**325 - 327 Deansgate – Manchester**

Non Material Amendment | 22 August 2022

10185-A-B5D8-RP-DAS-002

## 1.0 Introduction

### Second Floor Plan

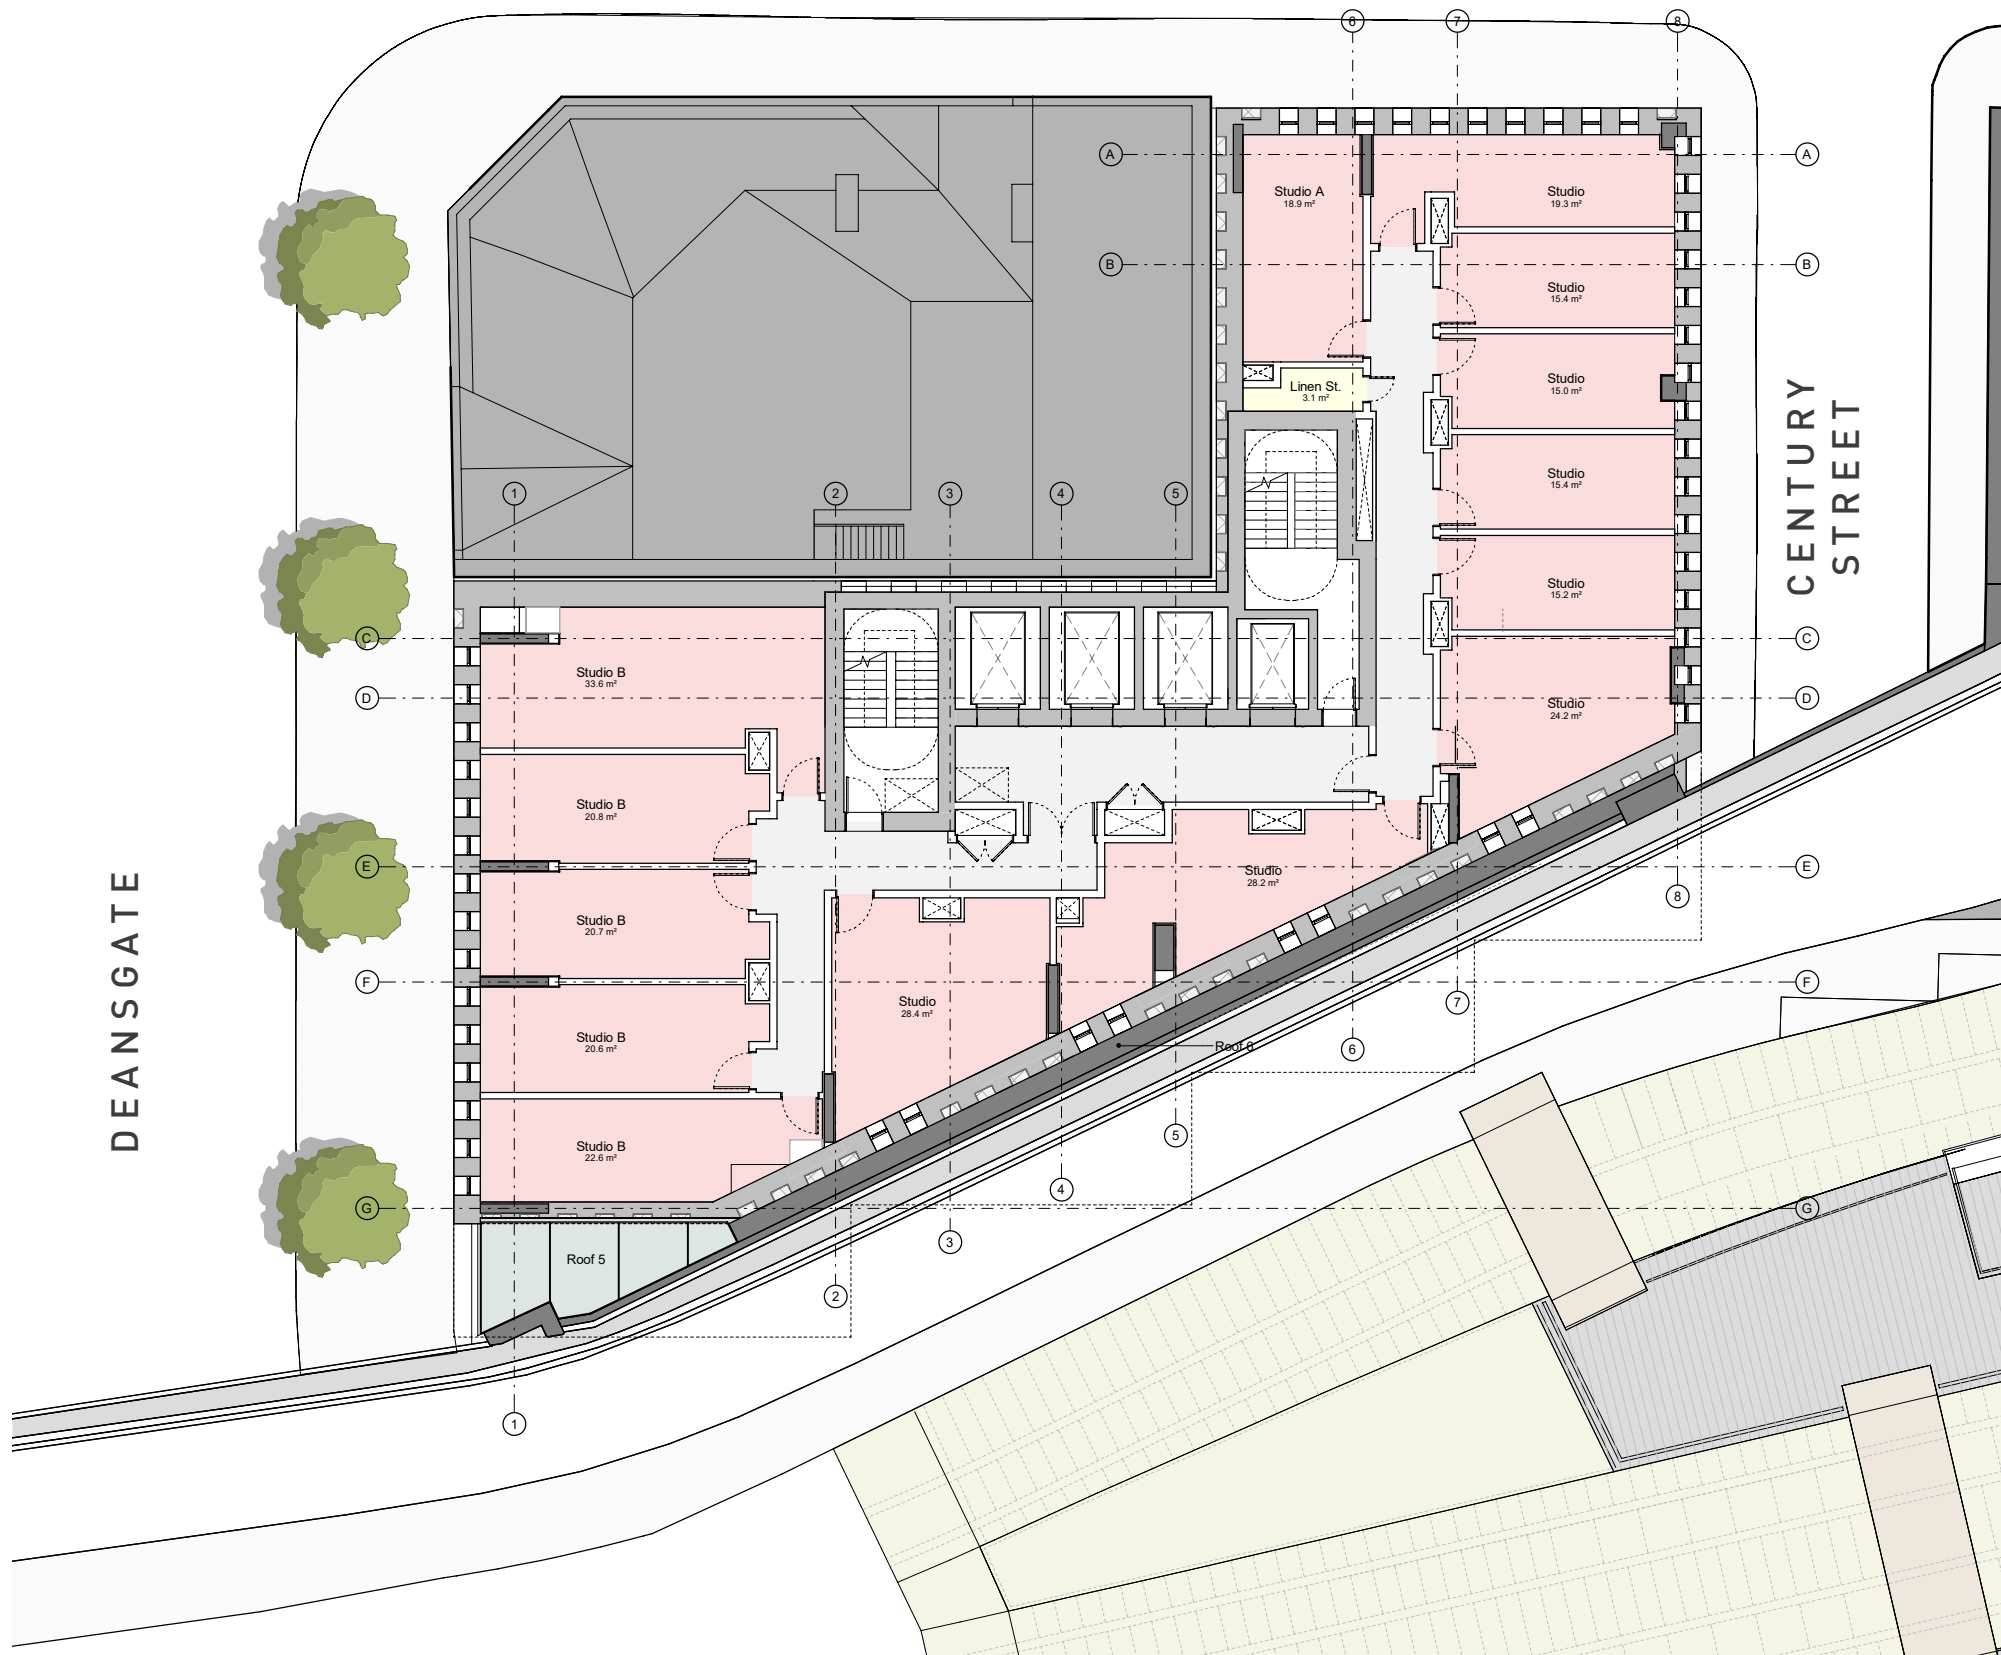
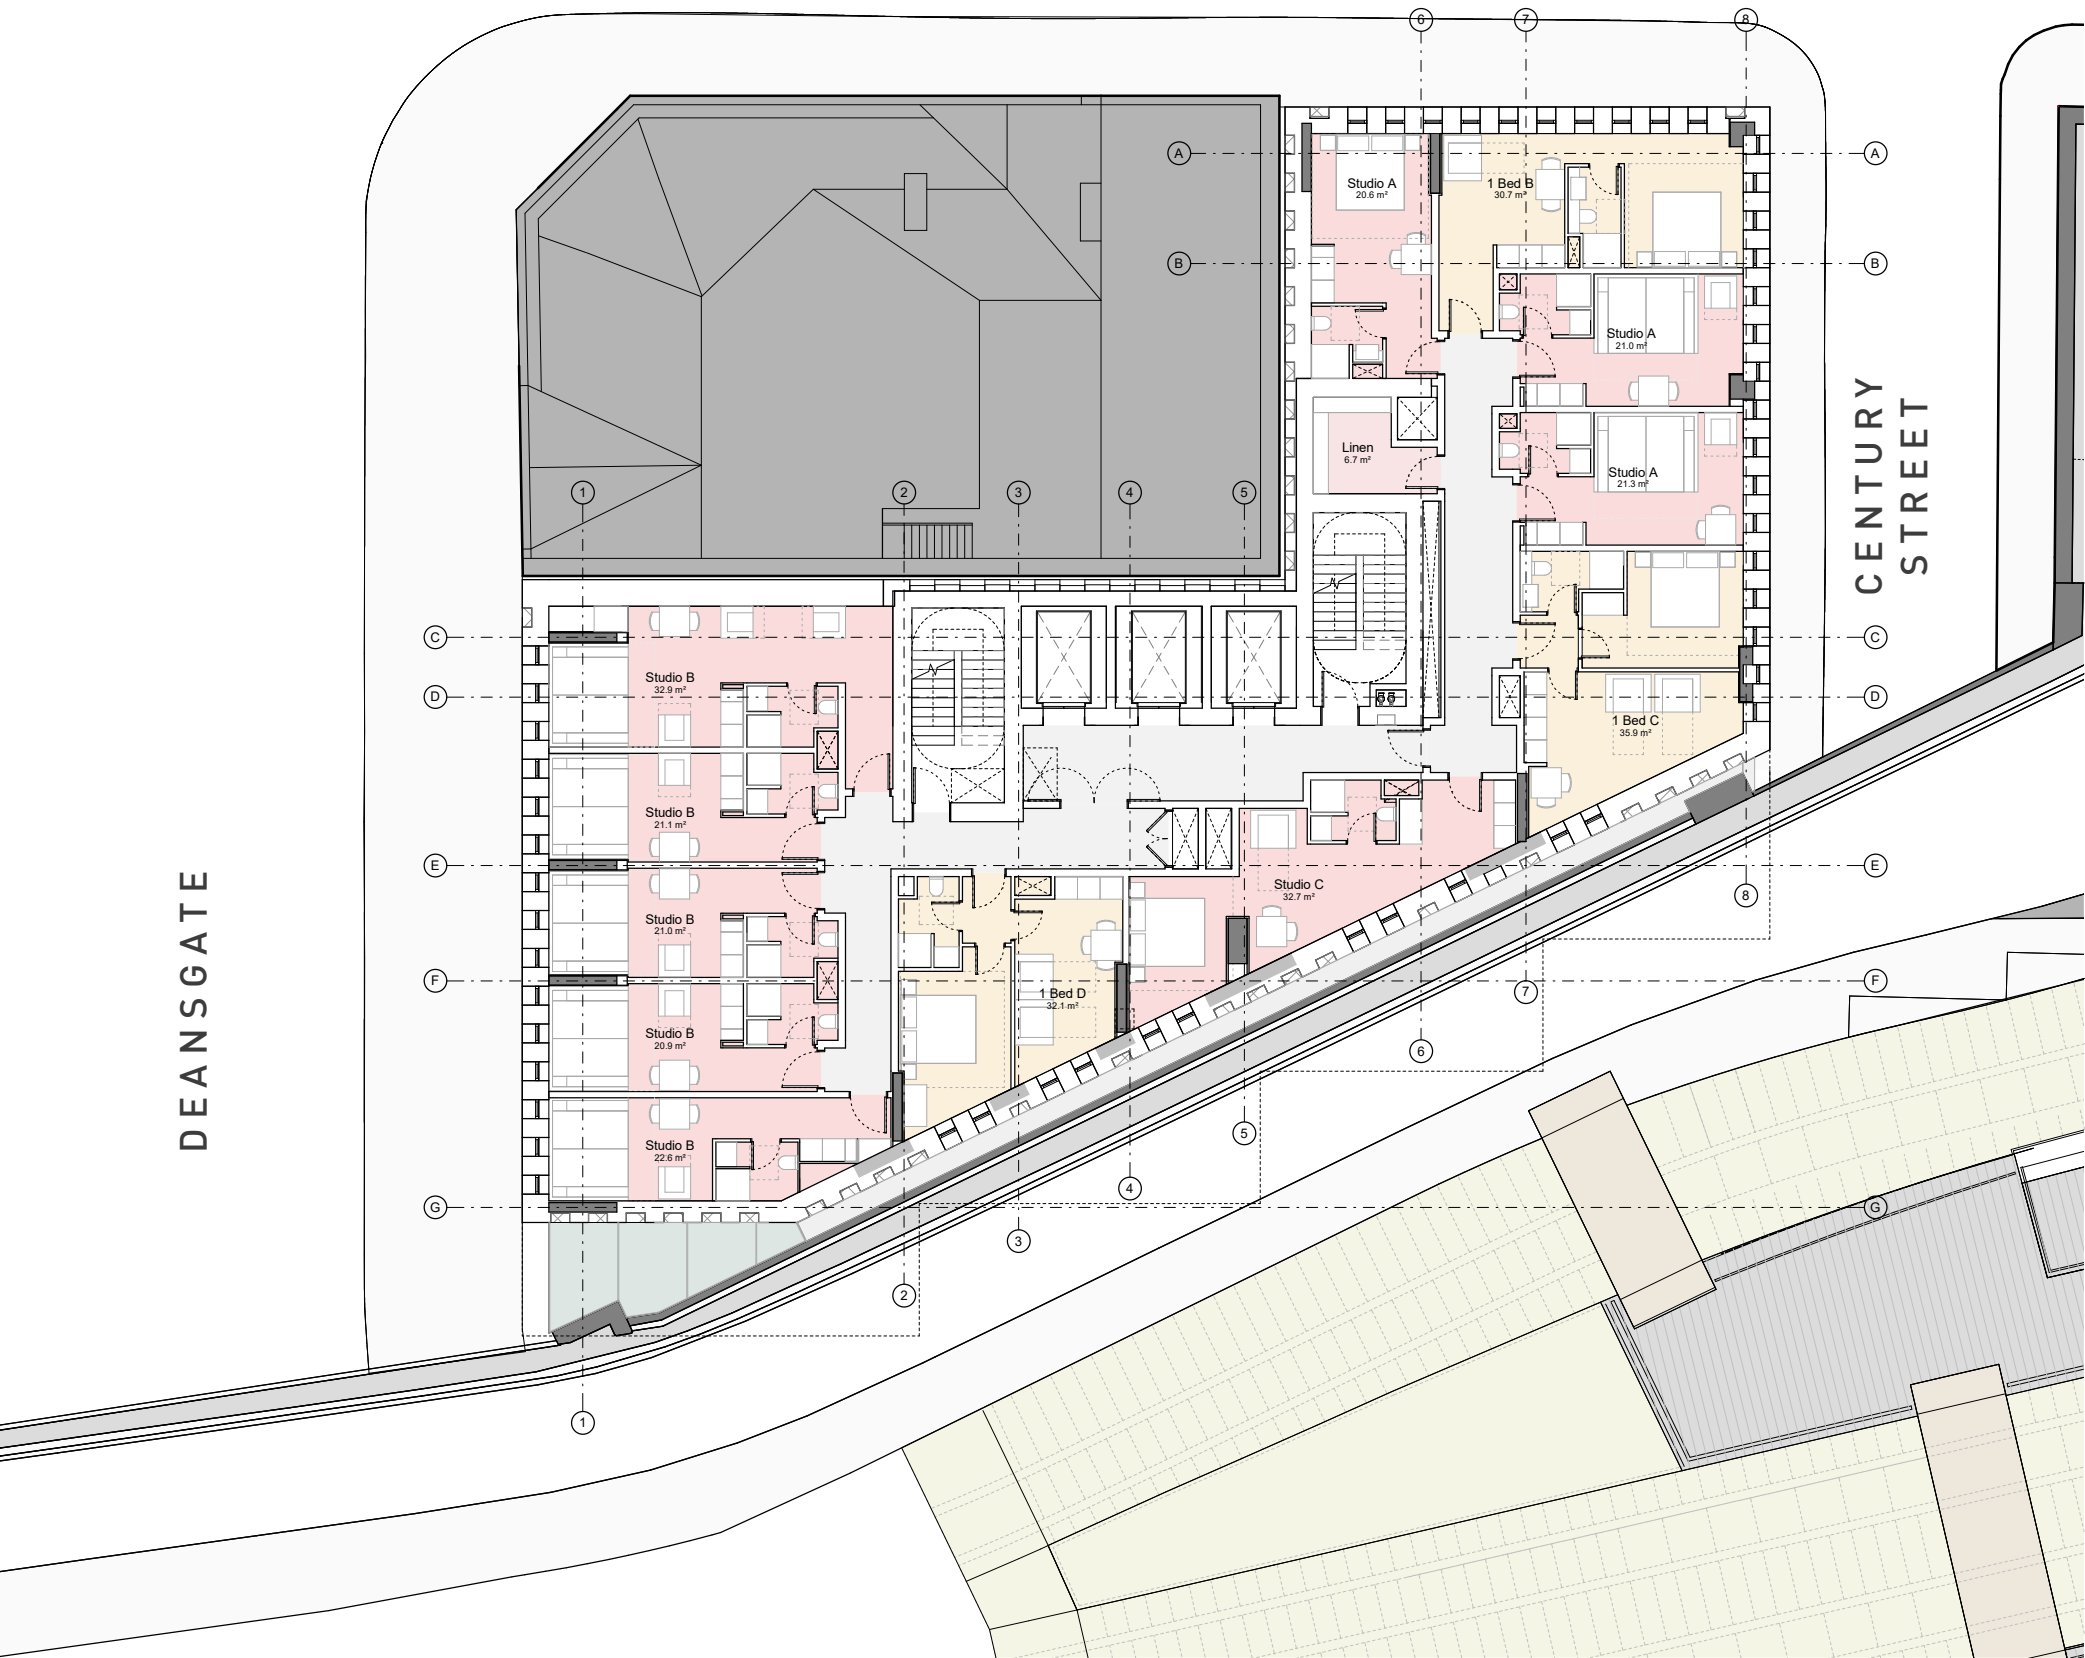
Amendments at Second floor.

- Lift/stair arrangements amended as described at ground floor.
- Gym and luggage store moved to lower levels and hotel rooms added on viaduct frontage
- Hotel room layout on Century Street frontage amended to introduce standard hotel rooms.

## Third Floor Plan

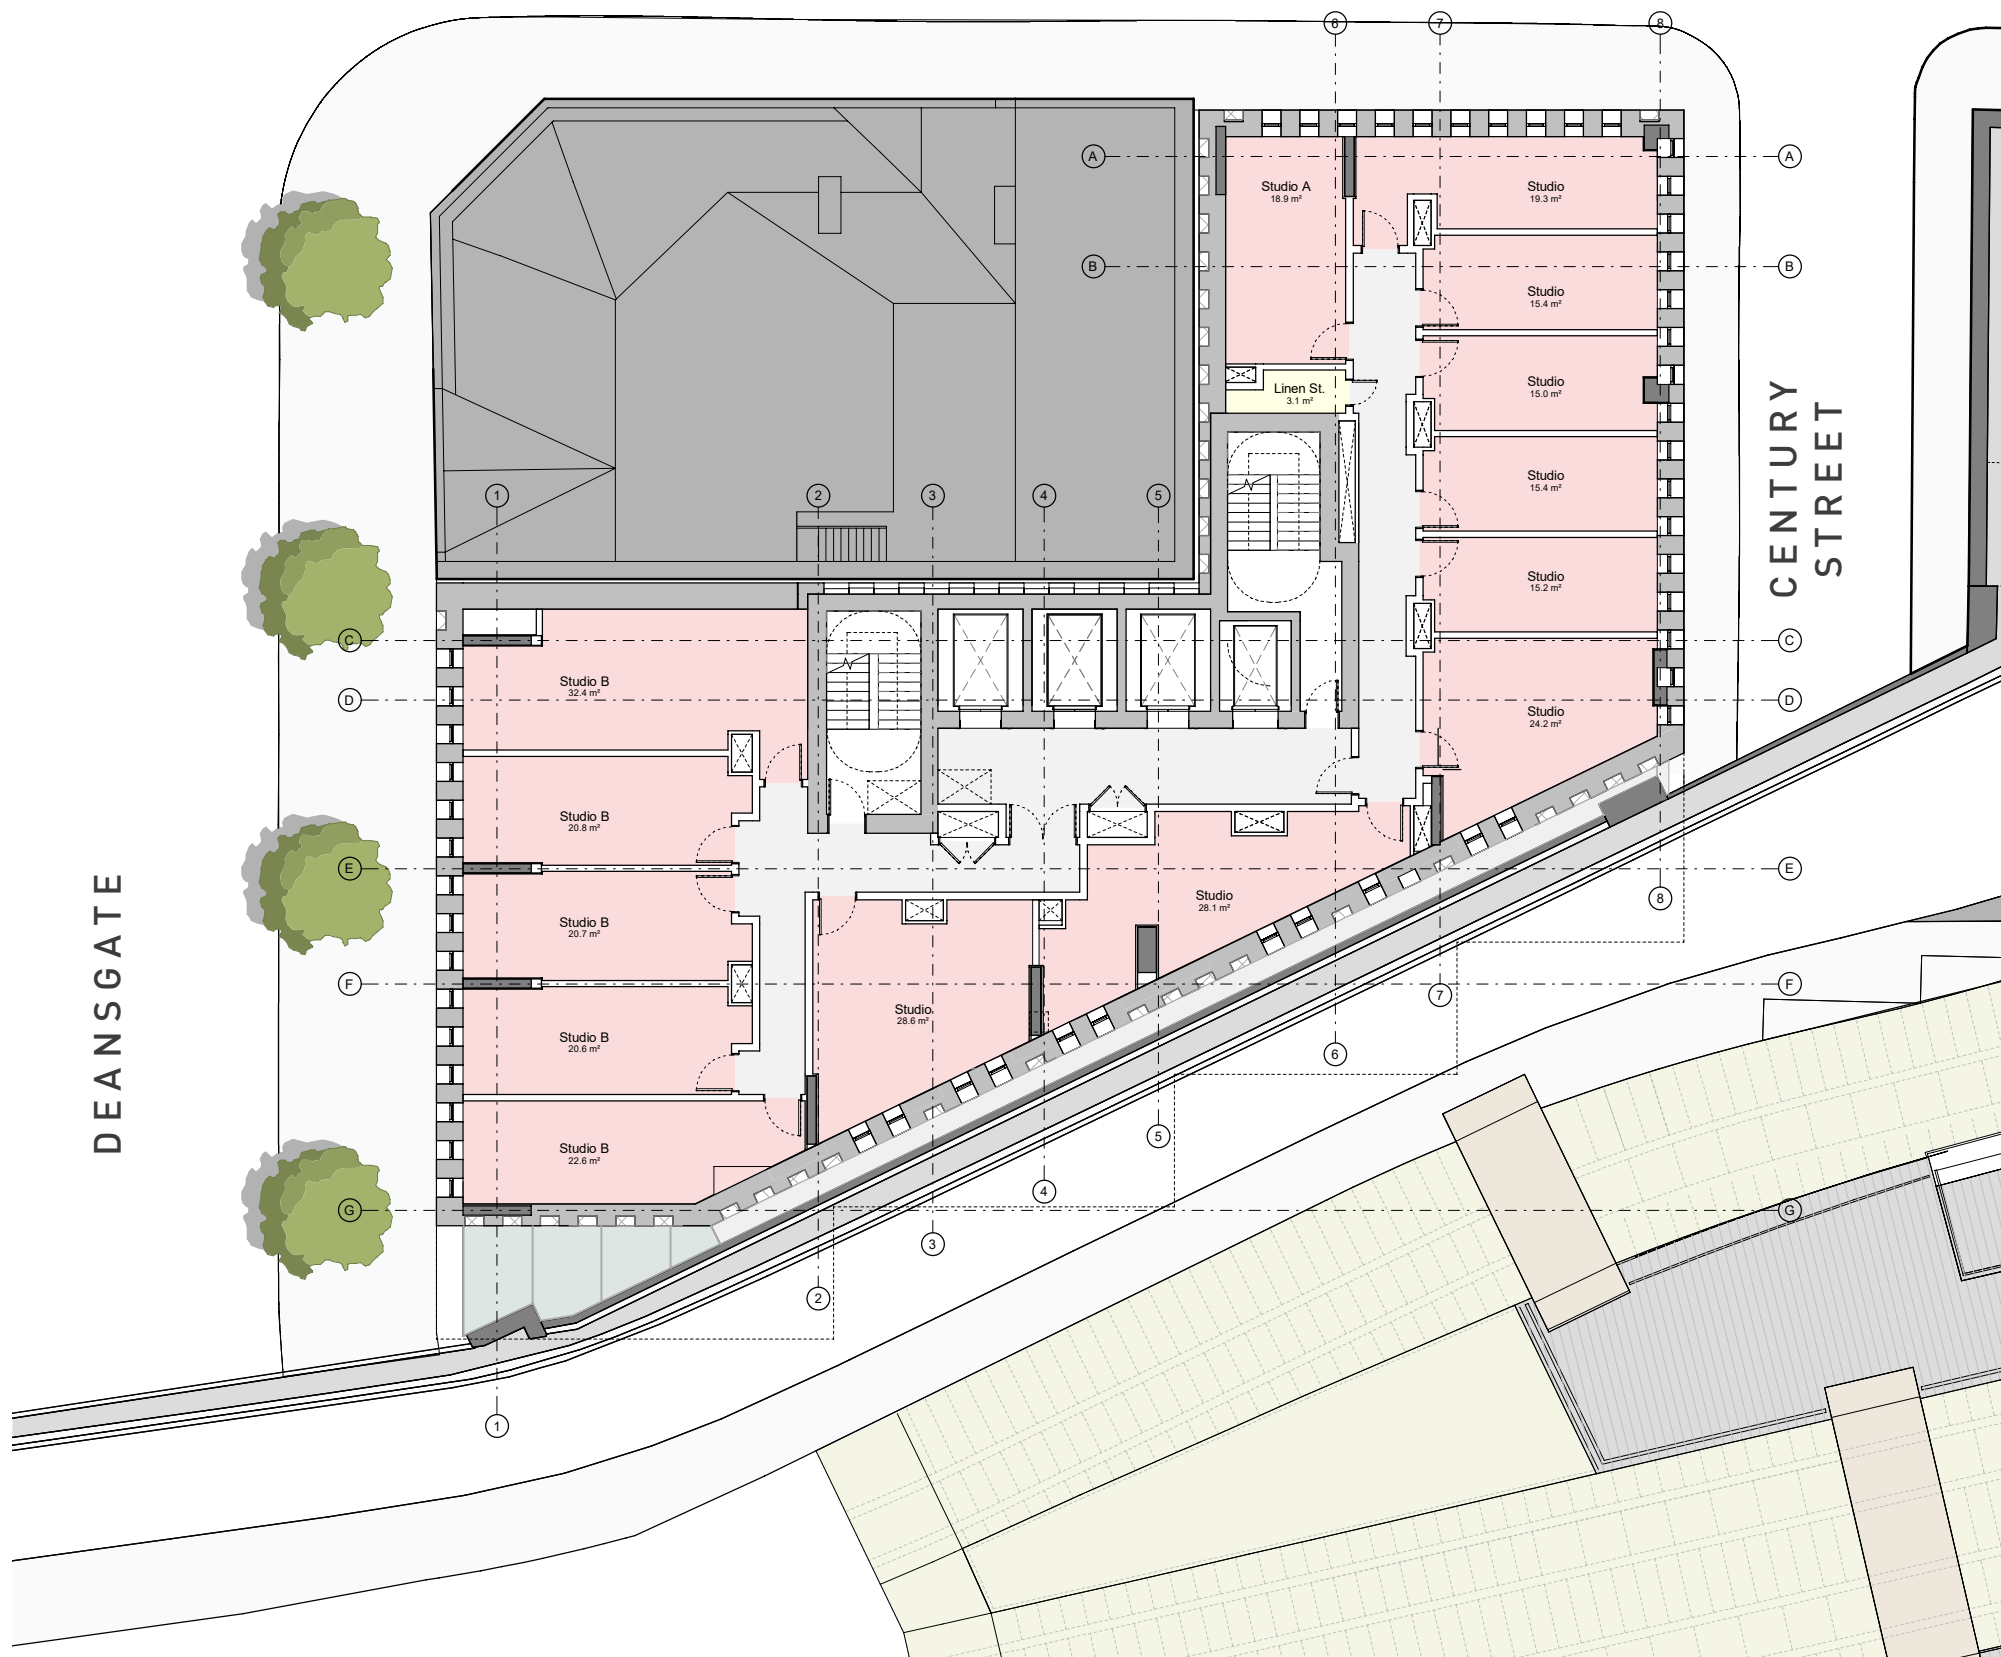
Amendments at Third floor.

- Lift/stair arrangements amended as described at ground floor.
- Hotel room layout on Century Street frontage amended to introduce standard hotel rooms.
